<p style="text-align: center;">Planning and Zoning Commission</p> <p style="text-align: center;">STAFF REPORT</p>	<p style="text-align: center;">AGENDA</p> <p style="text-align: center;"># _____</p>
---	--	--

DSA-15-00038: Santa Cruz Crossing Preliminary Plat to divide property within the Santa Cruz Crossing Planned Area Development into seven lots to accommodate future development.

Staff recommends the Commission approve the Preliminary Plat DSA-15-00038 subject to the following technical conditions:

Exhibit B- Preliminary Plat (excerpt)

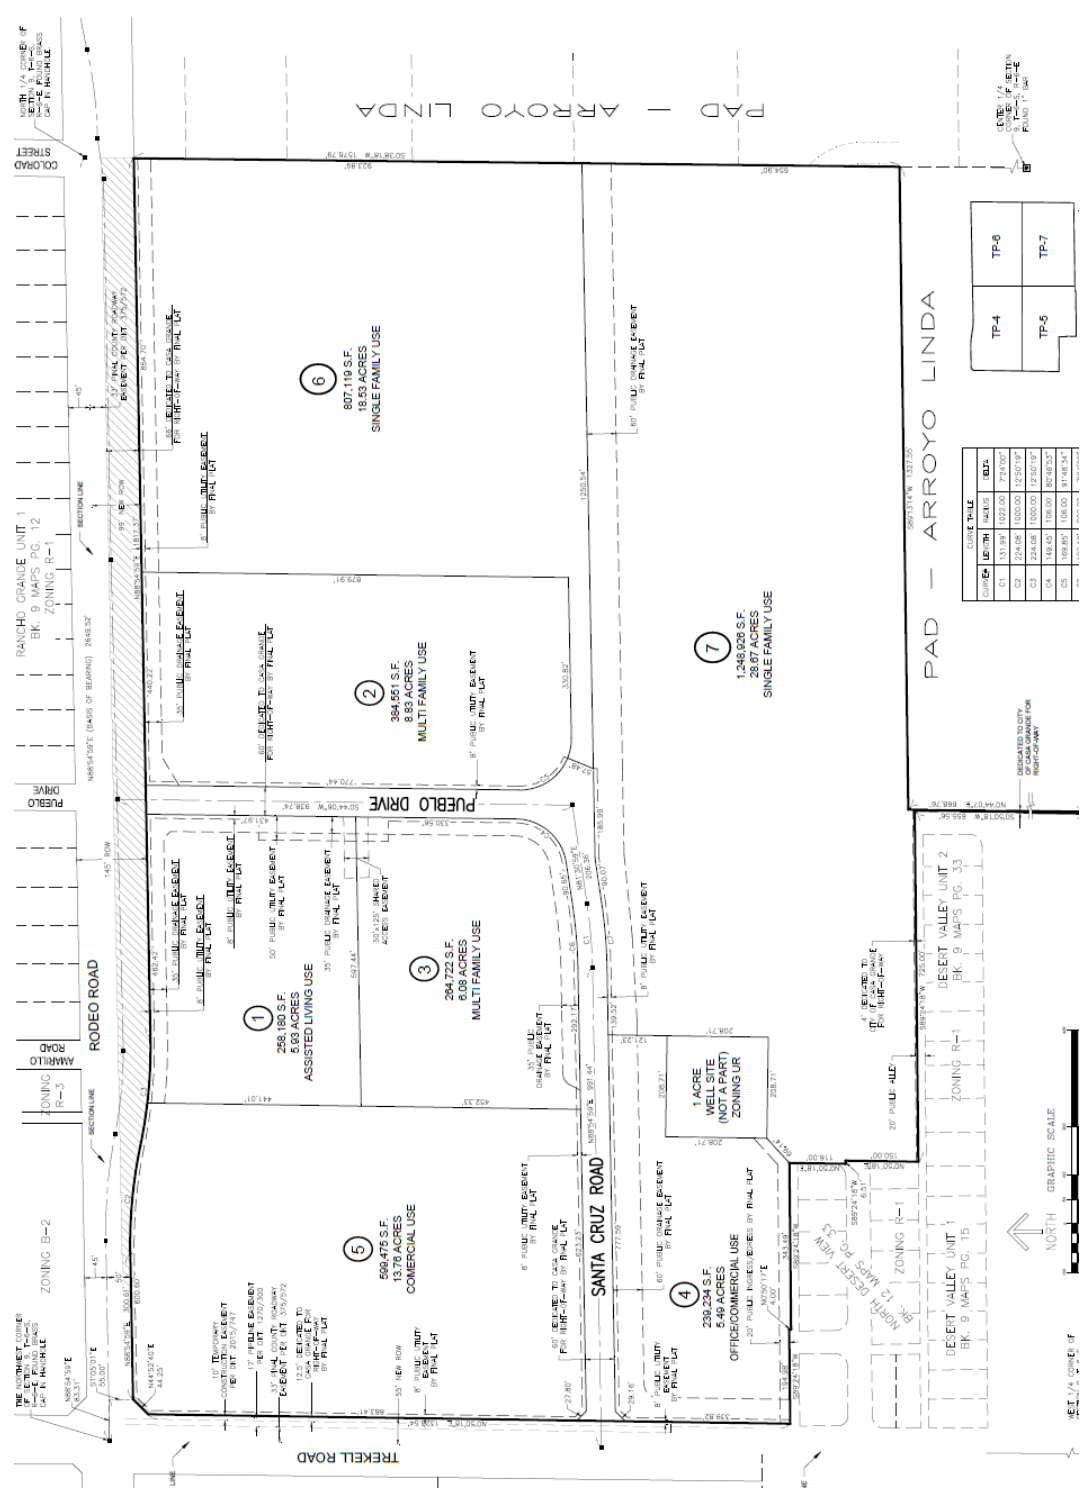
3. Identify and call-out dimensions of those parcels adjacent to the site along Trekell Rd. at and at the NW corner of Trekell Rd. and Rodeo Rd. that are owned by the City of Casa Grande. These parcels are known by APN: 505-07-024B, 505-07-024C, and 505-07-025B (sheet 2).
